# City of West Allis

### Plan Commission

Wednesday, October 25, 2023

**STAFF REPORT  
WEST ALLIS PLAN COMMISSION  
Wednesday, October 25, 2023  
6:00 PM**

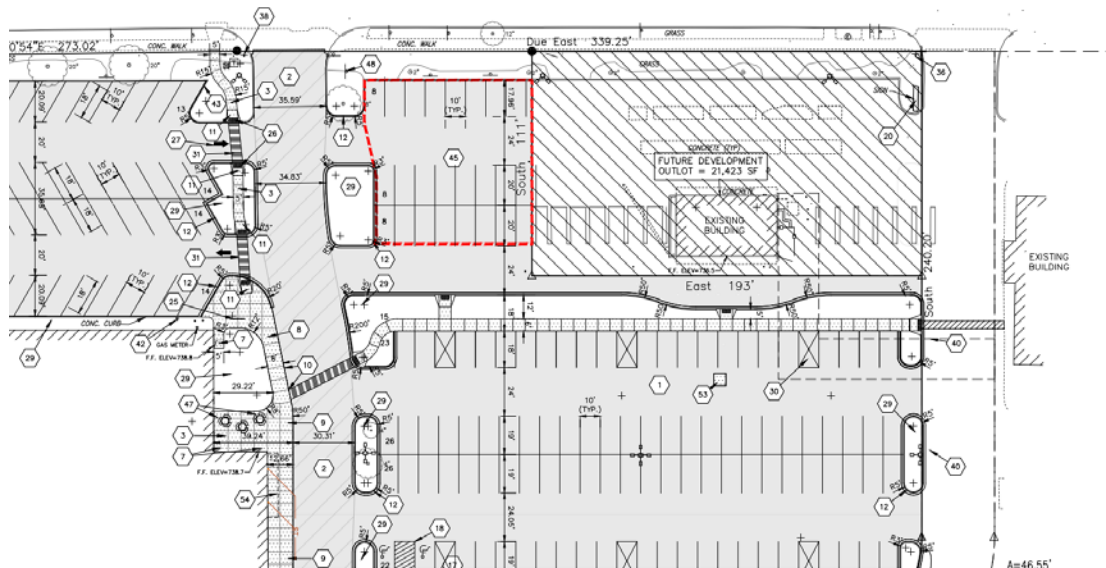
Access to the building is provided by an access drive from W. Greenfield Ave that connects internally to the proposed Checker's parking lot. Parking is situated to the rear of the proposed building. The proposed parking area includes 11 stalls; 10 are allowed by code. No bike parking is shown; 2 spaces (1 rack) are required by code

A trash enclosure is shown on the site in the parking lot. Checker's parking lot is buffered from Festival Food's existing parking lot by a landscape island. This landscape island will also serve as a pedestrian pathway that is required as part of a previous approval related to Festival Food's (See next page for details). Staff is recommending that this is shown on a revised site plan, along with an additional internal pedestrian connection to the public sidewalk along Greenfield Ave.

1. Common Council approval of the Conditional Use Permit (scheduled for November 14, 2023).
2. Submit revised site, landscaping, and architectural plans to the Planning & Zoning office to show the following: a) replace EIFS with higher quality building material; b) removal of 1 parking space to comply with Sec. 19.44(2); c) addition of outdoor bike rack to comply with Sec. 19.44(3); d) landscaping planting plan approved by City Forestry e) incorporate an internal pedestrian walkway across the parking area (**per Festival site plan approval**) and connecting properties to W. Greenfield Ave. from the new internal walkways.

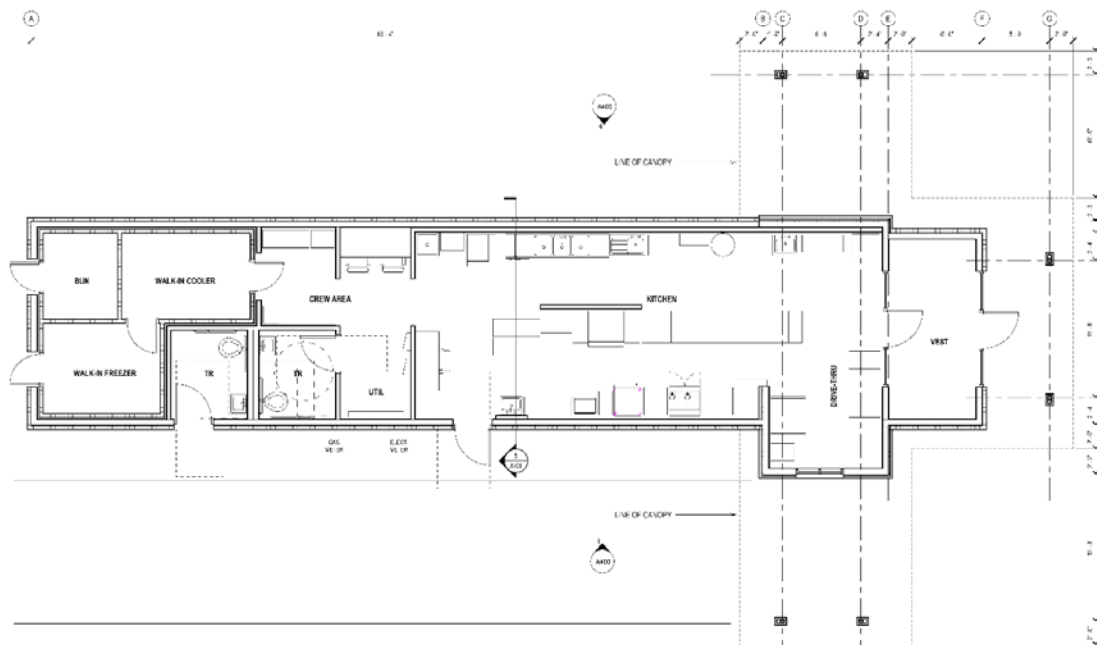
The proposed façade includes EIFS (white and red), glass paneling (multi-color), stainless steel cladding, and prefinished metal cladding (black). Staff advised the applicant that EIFS is not an accepted material; the applicant agreed to change EIFS to a higher quality material. The majority of the building is shown in a red color, customary to Checker's branding. Checkerboard designs appear on portions of the north, east, and south facades, providing visual interest. A mural is proposed on the north façade of the building.

The applicant has agreed to replace this with a higher quality material; at that point the project will satisfy all design guidelines.

### Site & Landscaping Plan

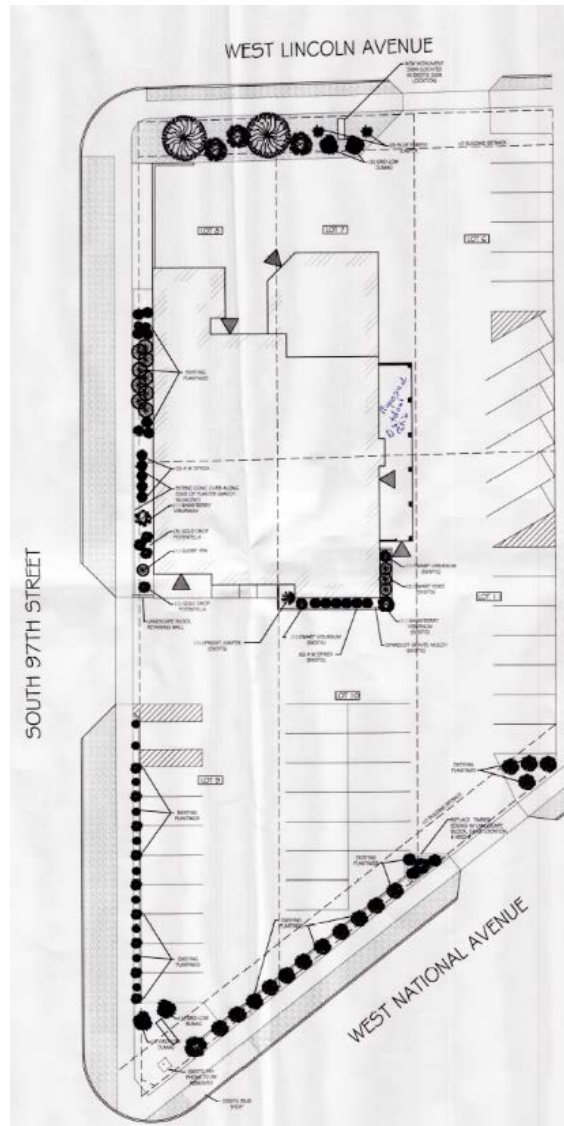
No site and landscaping changes are proposed. Site landscaping is in subpar condition. Staff recommends requiring a condition of approval that by May 2024, landscaping be refreshed in accordance with the approved site plan on file.

1. Landscaping maintenance in accordance with approved landscaping plan.
2. Repaint portions of façade showing significant wear.
3. Common Council approval of the Conditional Use Permit.

SITE PLAN  
**A0.41**

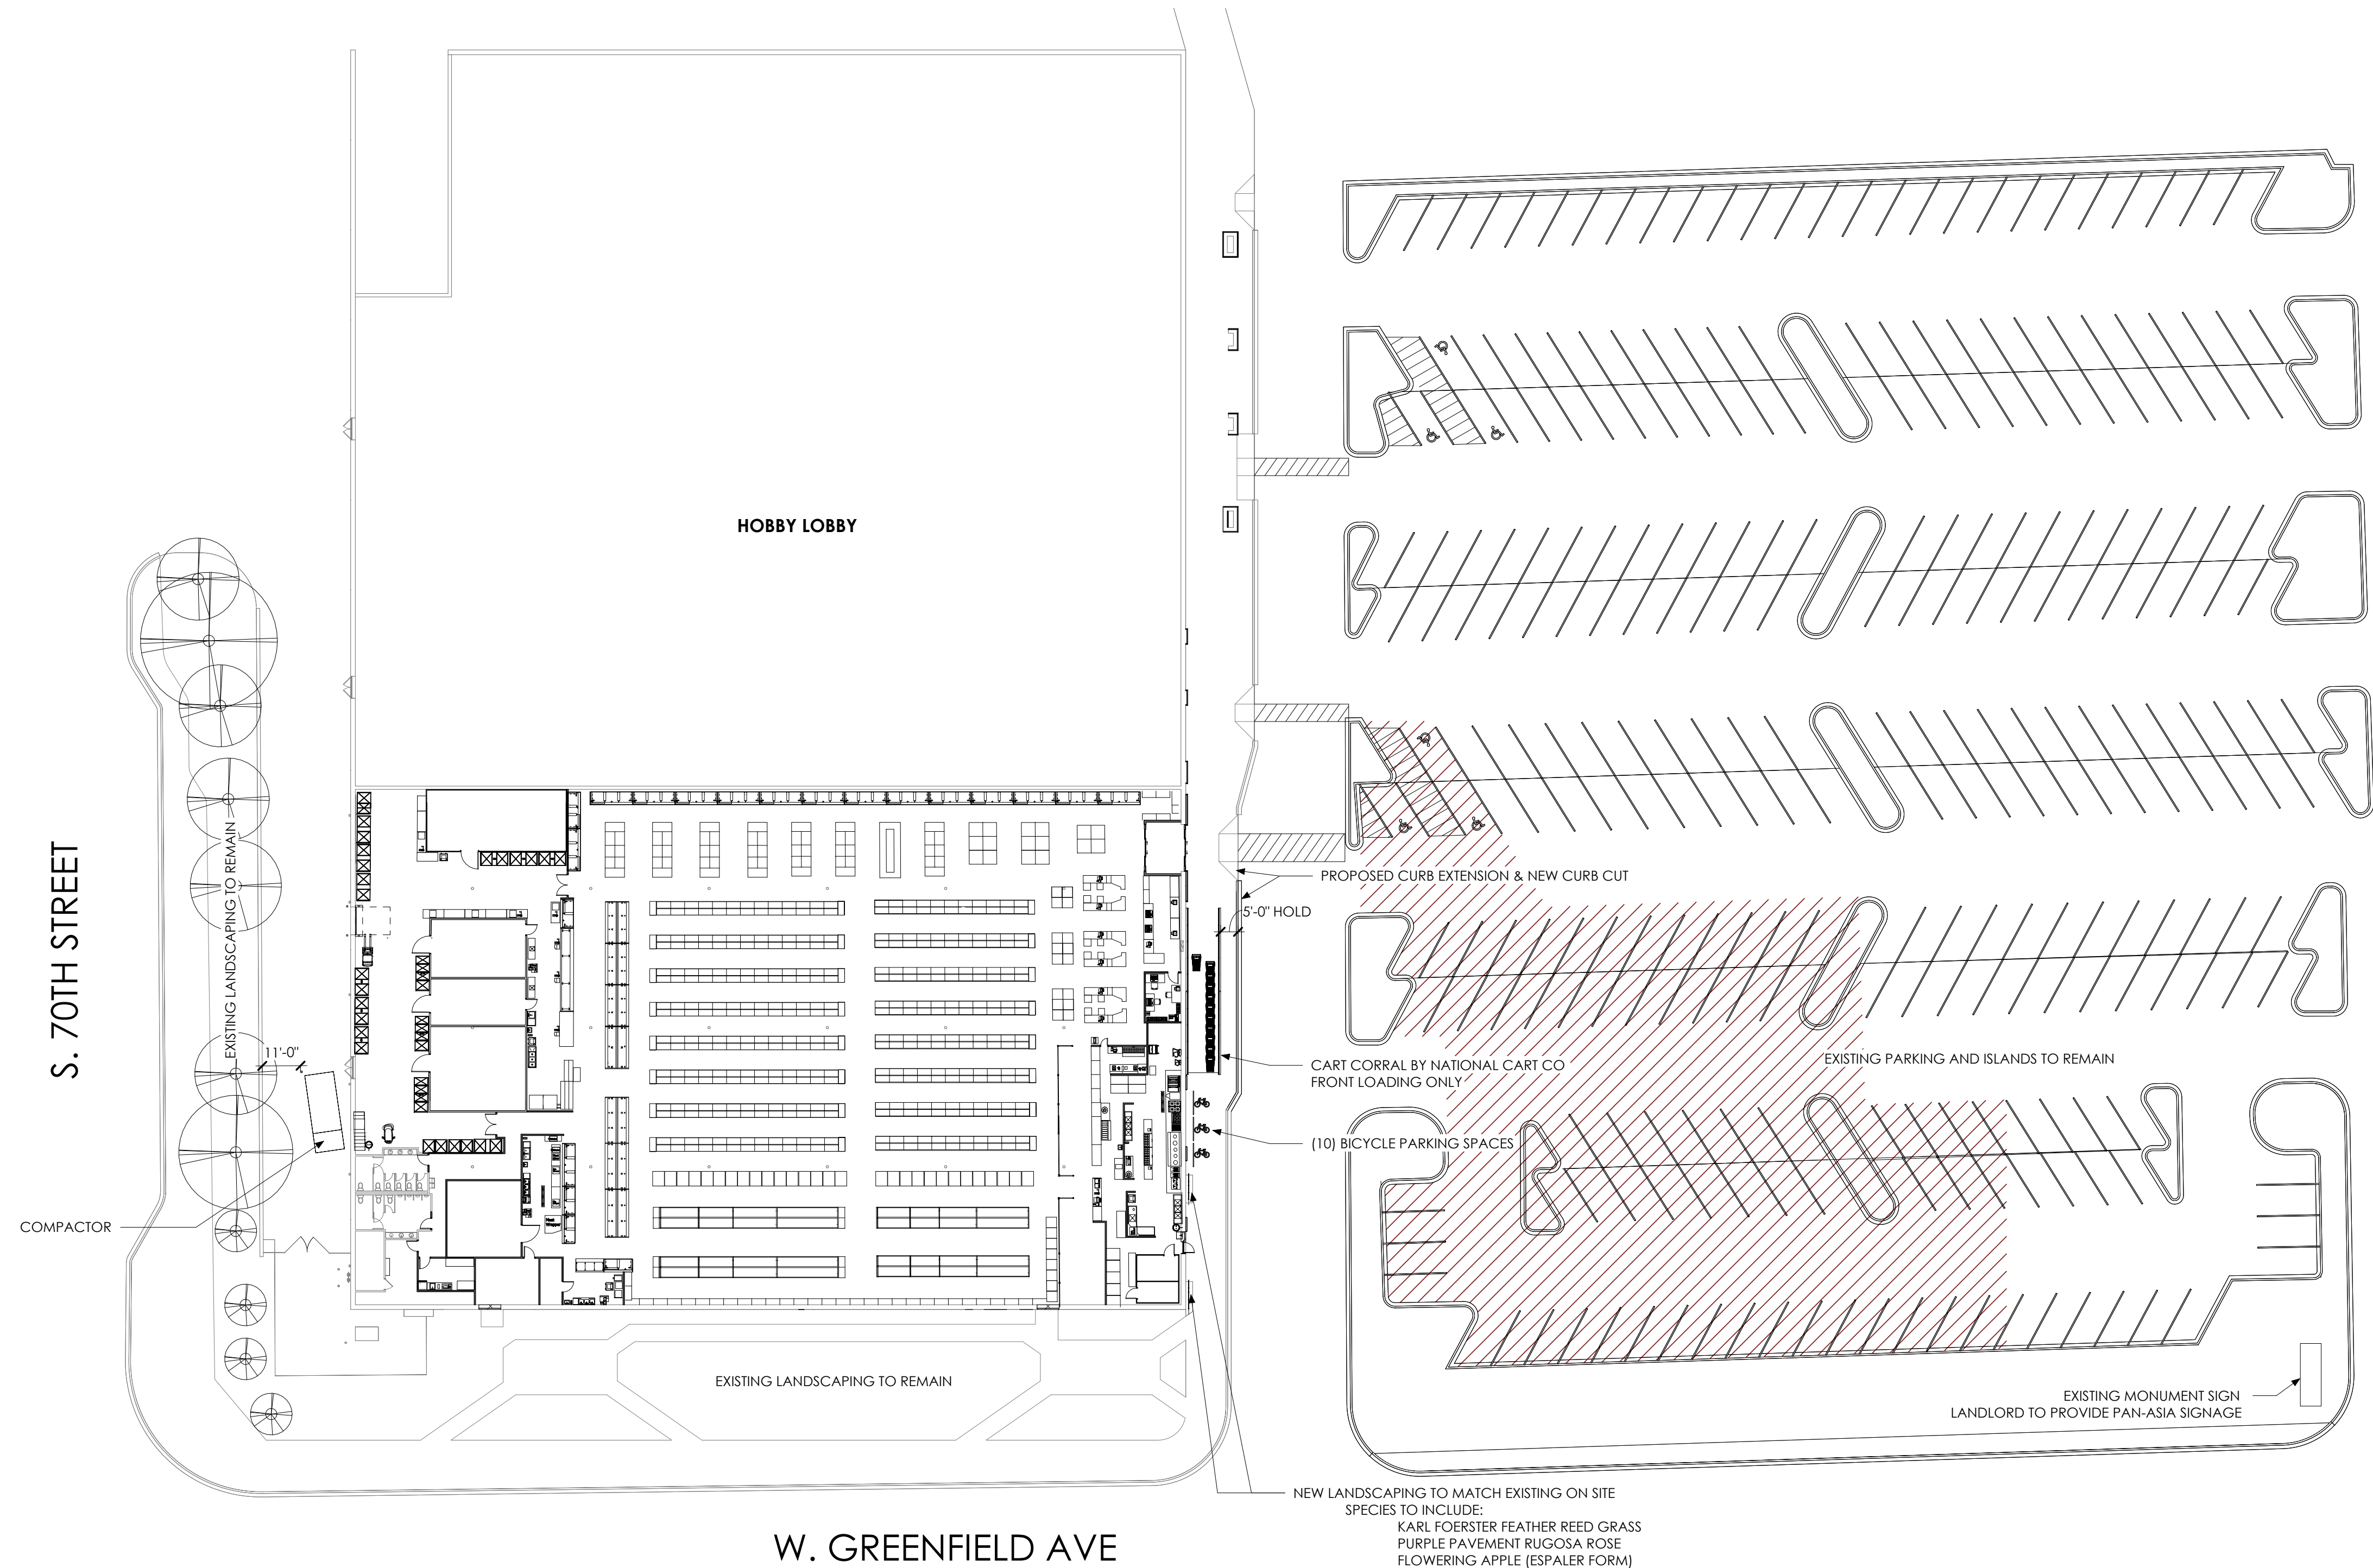
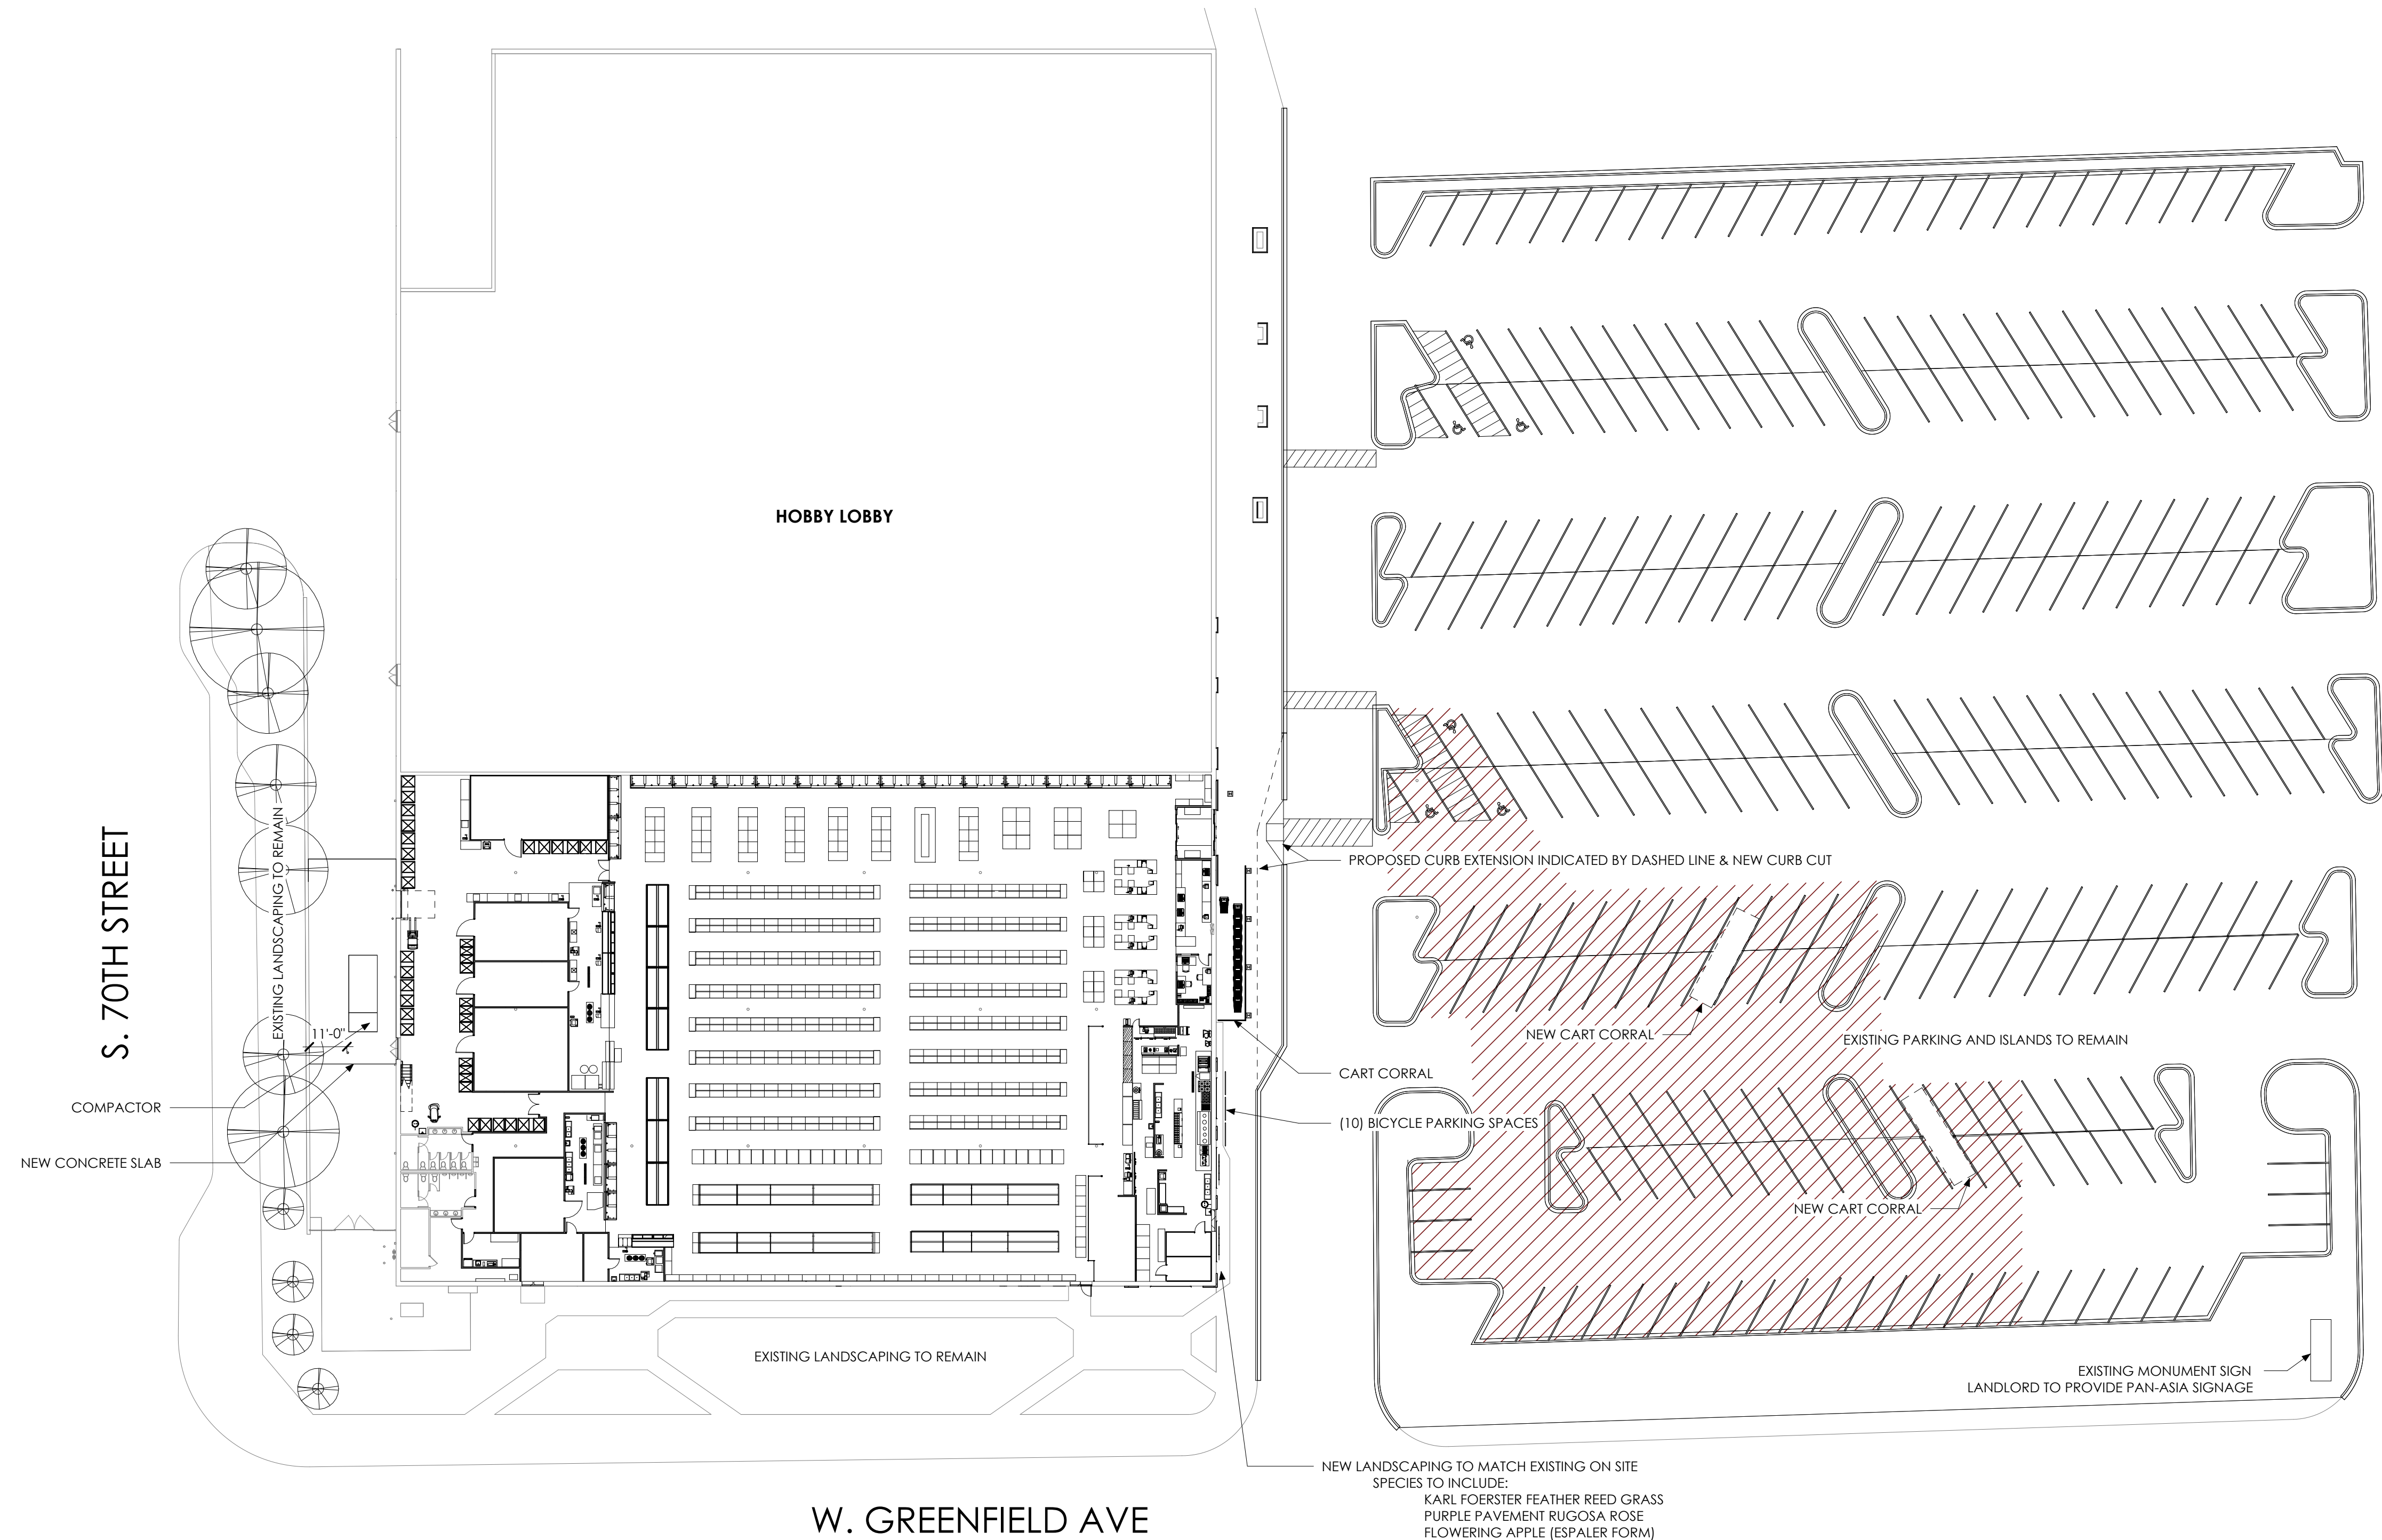
The initial staff comments (based on the original plan set), were shared with the applicants. Items 1 is recommended, item 2-3 satisfied (subject to minor details), and item 4 is simply a consideration staff shared with the applicant:

1. Submit revised site, landscaping, and architectural plans to the Planning & Zoning office to show the following: a) a detail of the proposed exterior wood screens in steel frames on the facade; b) rooftop plan and screening material details; (c) cart corral details; (d) curb extension added along storefront pedestrian walkway.
2. A driveway permit being applied for with City Engineering Department for work within the City Right-of-Way.
3. Signage plans being submitted for sign permit review.
